Subject: Independent School District #834
Submittal to City of Lake Elmo on behalf of Stillwater Area Public Schools, for the proposed New Lake Elmo Elementary School project, located at the intersection of Lake Elmo Avenue North and Tenth Street North, Lake Elmo, Minnesota (Property ID #2602921440001)

Comprehensive Plan Amendment and Zoning Map Amendment Submittal Narrative:

NEW LAKE ELMO ELEMENTARY SCHOOL

01/19/2024 - LAKE ELMO ELEMENTARY
 ZONING MAP AMENDMENT SUBMISSION
(CONCEPTUAL PLAN - DO NOT USE FOR CONSTRUCTION)

**CONCEPTUAL -
SITE PLAN**

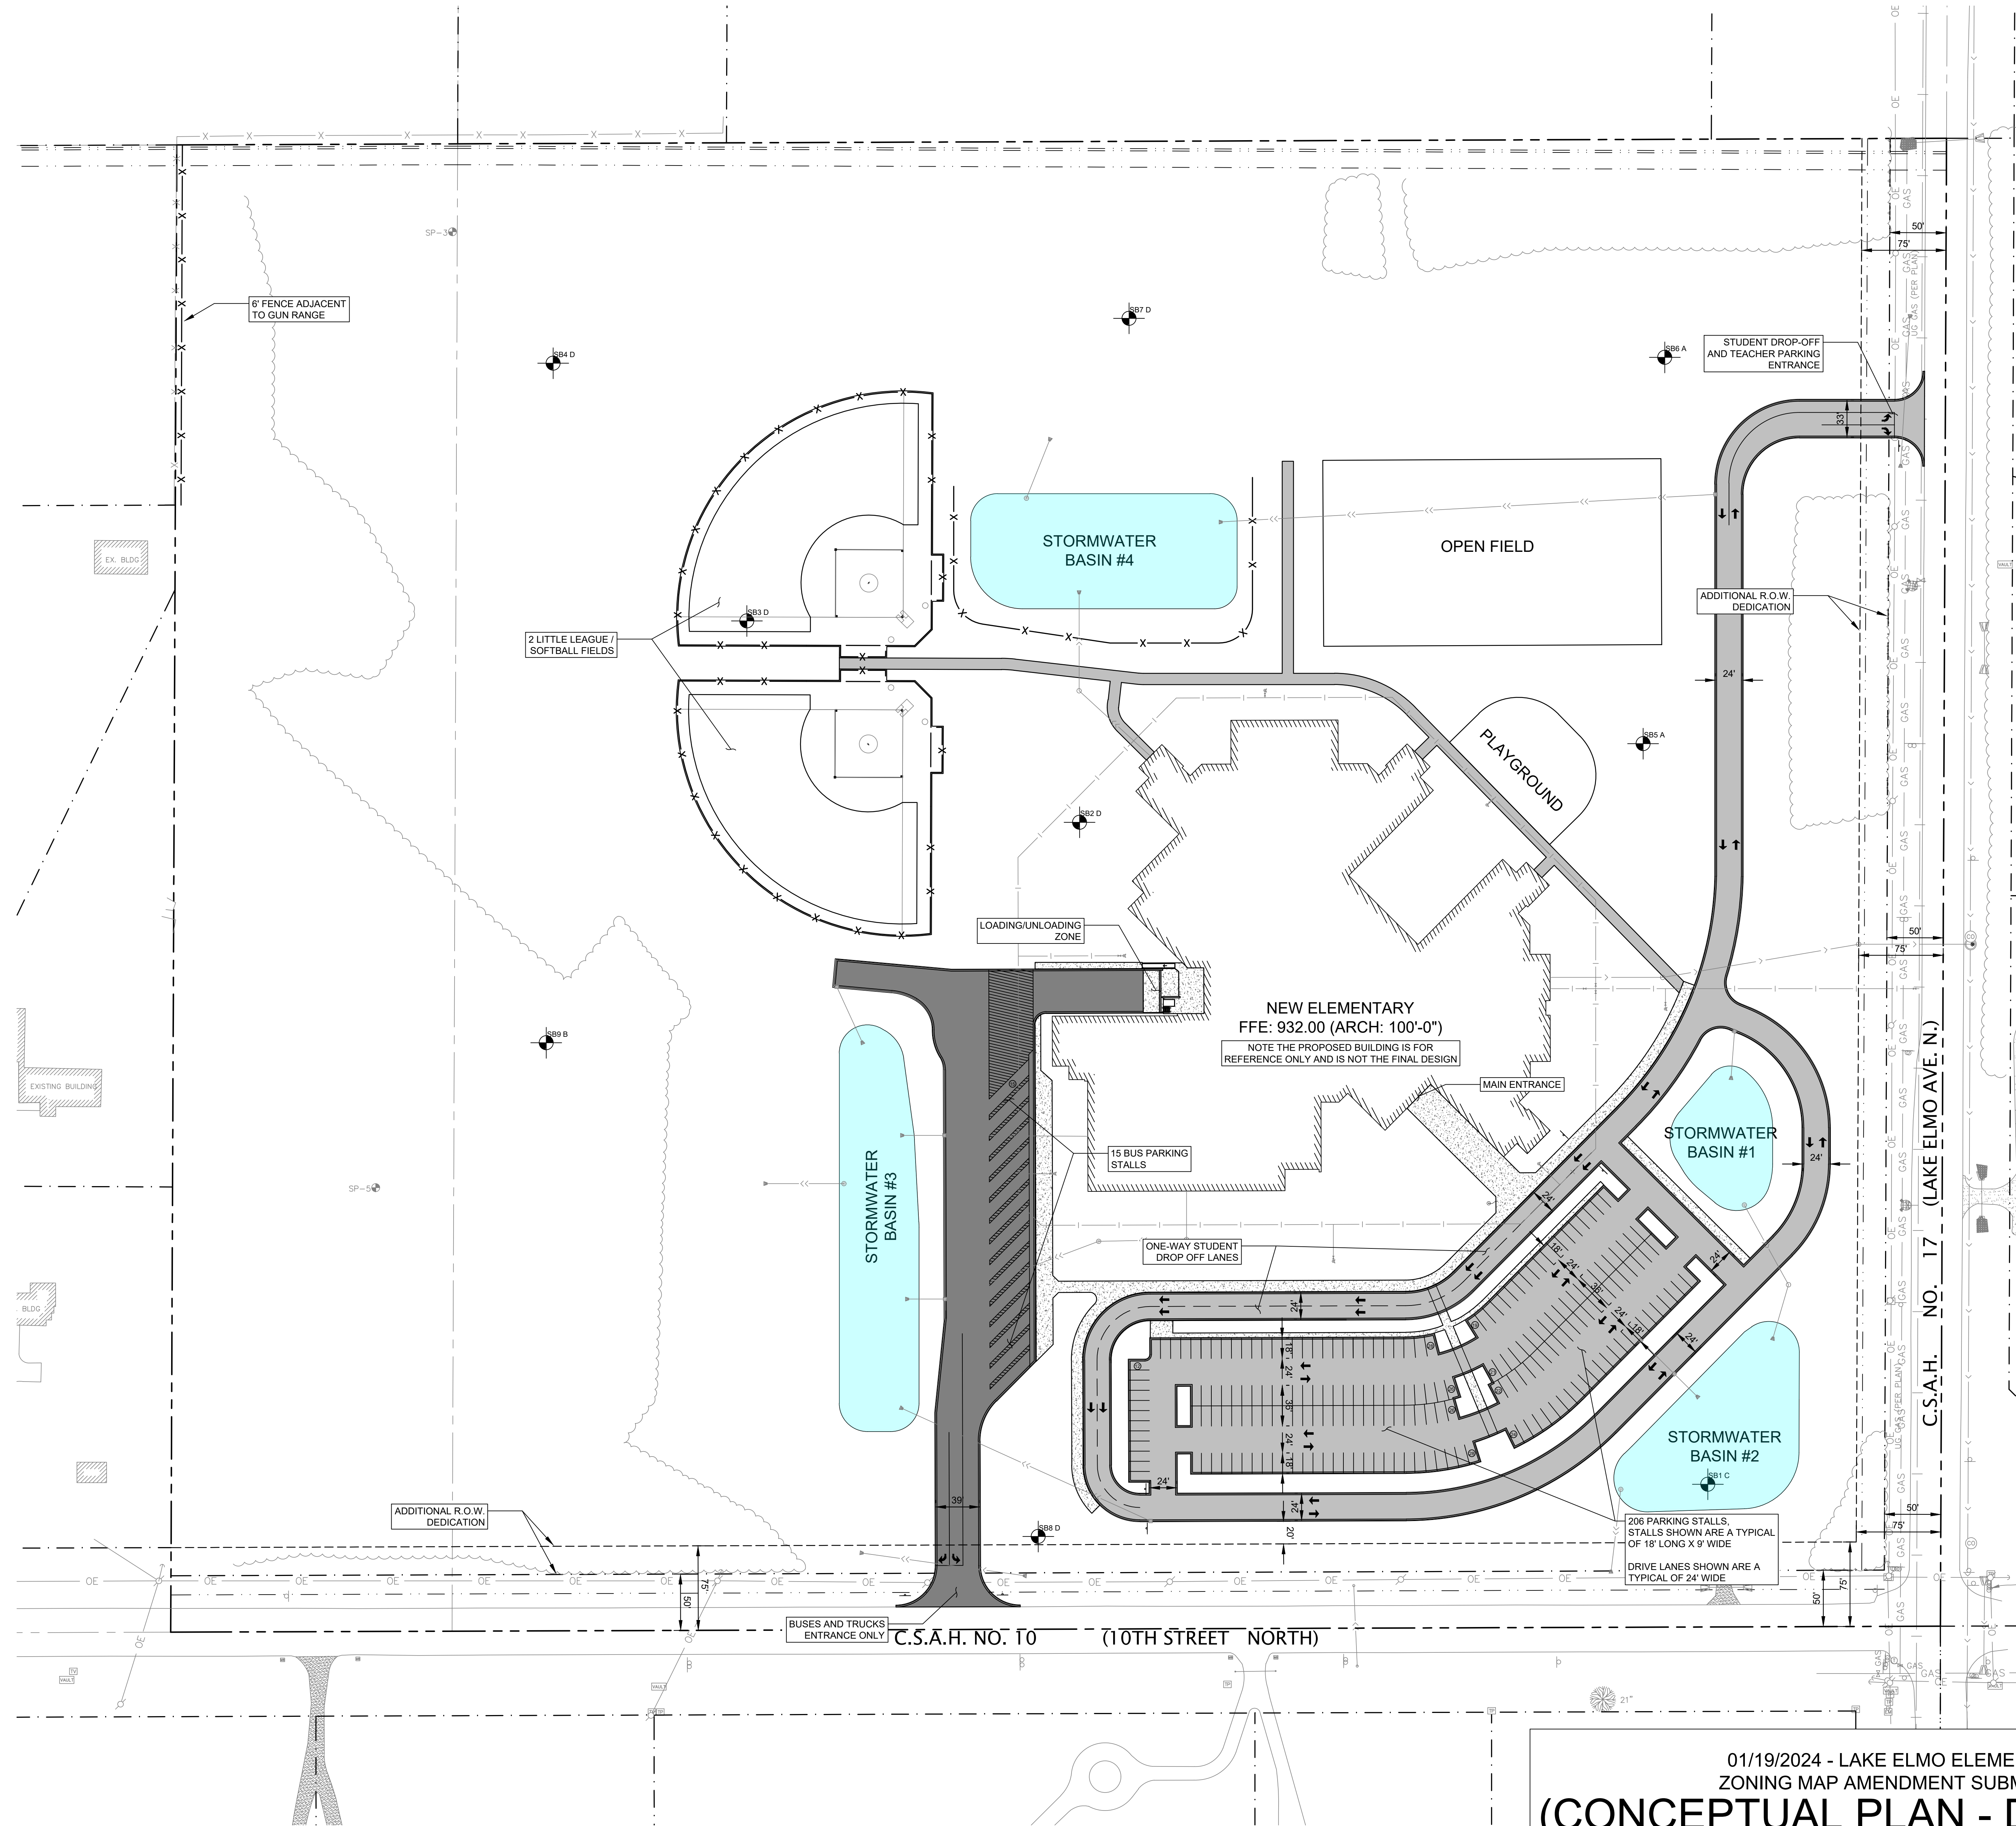
4. Turn Lane Improvements. As part of the site improvements, dedicated right and left turn lanes must be constructed along Lake Elmo Avenue (CSAH 17) and 10th Street (CSAH 10) at both access locations. The required turn lanes have not been shown on the proposed site plans. Turn lanes must be constructed meeting Washington County standards.

5. Secondary Access. The site shows a single access for busing and a single access for all other vehicles. Internal connectivity between the two access locations is not provided. Emergency vehicle access requirements must be reviewed and approved by the Lake Elmo Fire Department.

6. Traffic Signal Improvements. The installation of a traffic signal at the intersection of Lake Elmo Avenue (CSAH 17) and 10th Street (CSAH 10) should also be included as part of the site improvements to provide additional traffic control for peak demands as well as provide safe pedestrian crossings at the intersection.

7. Bituminous Trails. The site improvements must include and show on the site plans the construction of a bituminous trail along the full length both Lake Elmo Avenue (CSAH 17) and 10th Street (CSAH 10). Pedestrian connectivity should be planned as part of the school site, including internal pedestrian connections, connection to the County Park Preserve, and safe pedestrian crossings for each County roadway at each access location.

**CONCEPTUAL -
UTILITY PLAN**

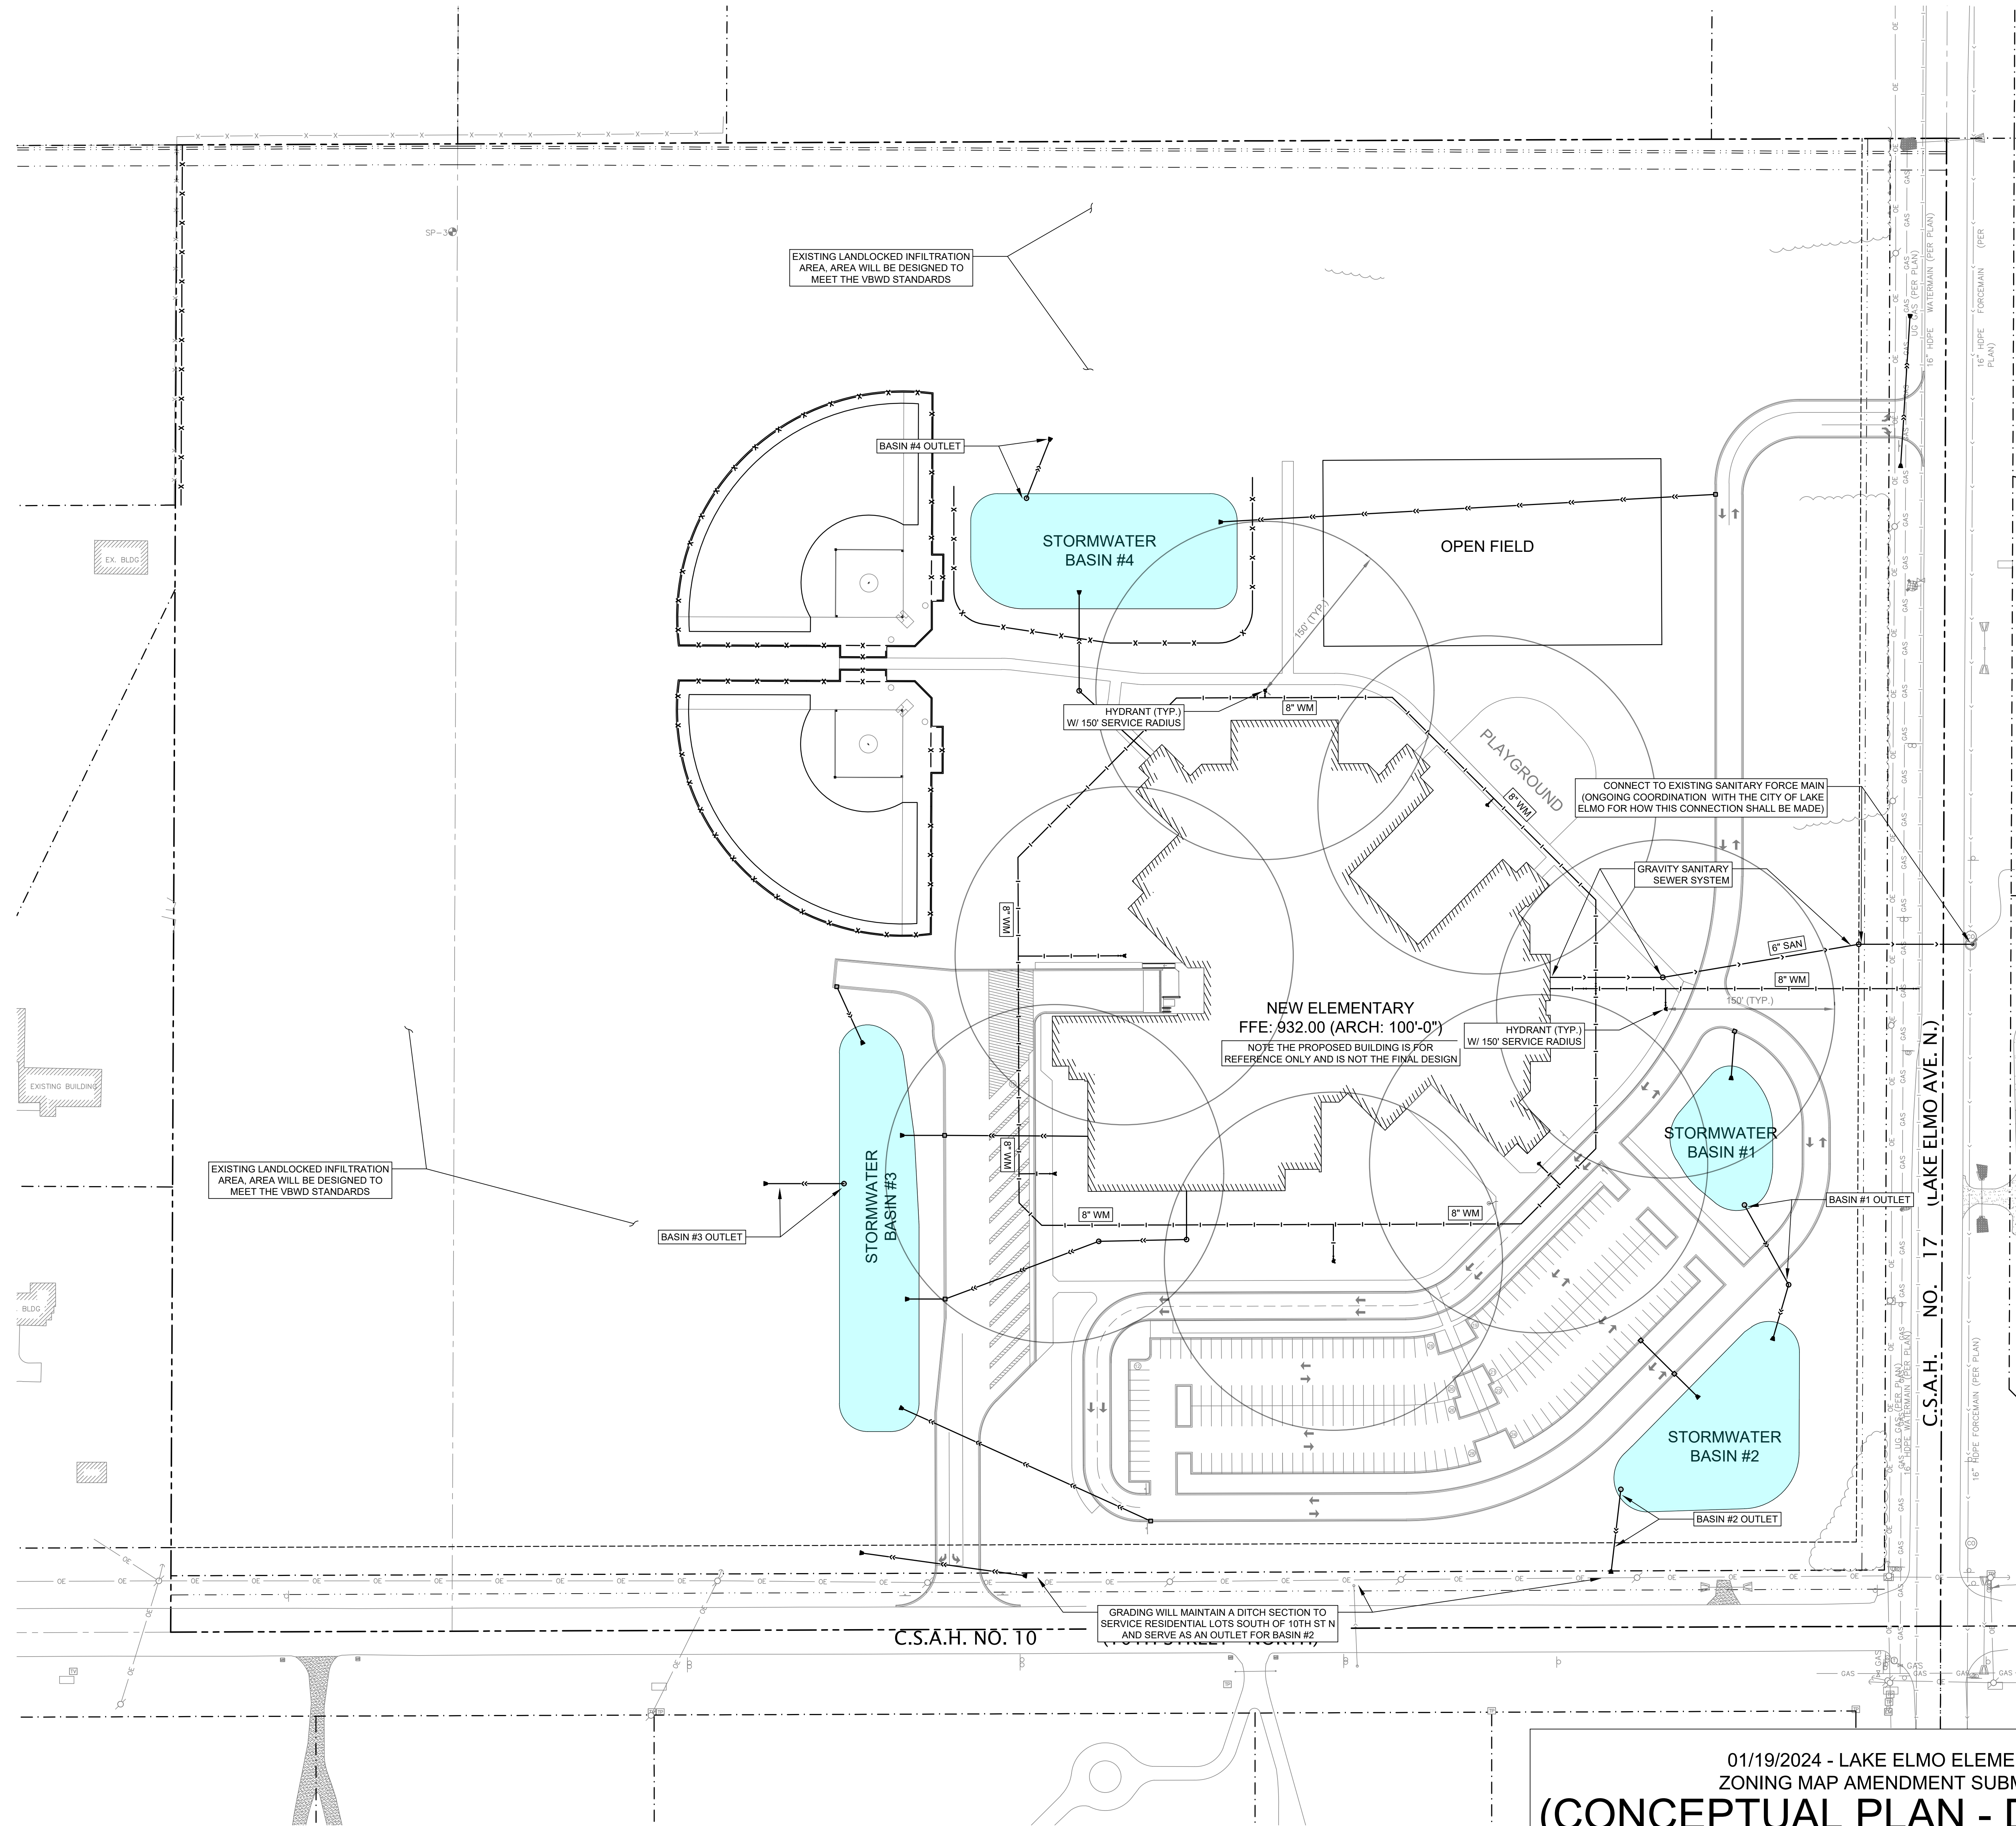
1. Due to the PFAS groundwater contamination in the surrounding area, all proposed uses on the property should be served by the City public drinking water supply.
2. Connection to the municipal water system is available to the existing trunk watermain running along Lake Elmo Avenue (CSAH 17). The applicant will be responsible for connecting to the existing 16-inch trunk watermain located near the proposed Lake Elmo Avenue (CSAH 17) driveway entrance and running a

minimum 8-inch ductile iron watermain internal to the site and throughout the property as necessary to provide connection to all proposed uses.

3. A second watermain connection will be required to create a looped network by extending the watermain south through the proposed 10th Street (CSAH 10) entrance, then east along 10th Street (CSAH 10) to connect back to the existing trunk watermain at the intersection with Lake Elmo Avenue (CSAH 17).

4. Watermain oversizing may be required to ensure adequate water supply and fire suppression once the site development water demands are known.
5. The project will require the placement of fire hydrants and water system valves internal to the site as determined by the Lake Elmo Public Works Director and Fire Department.
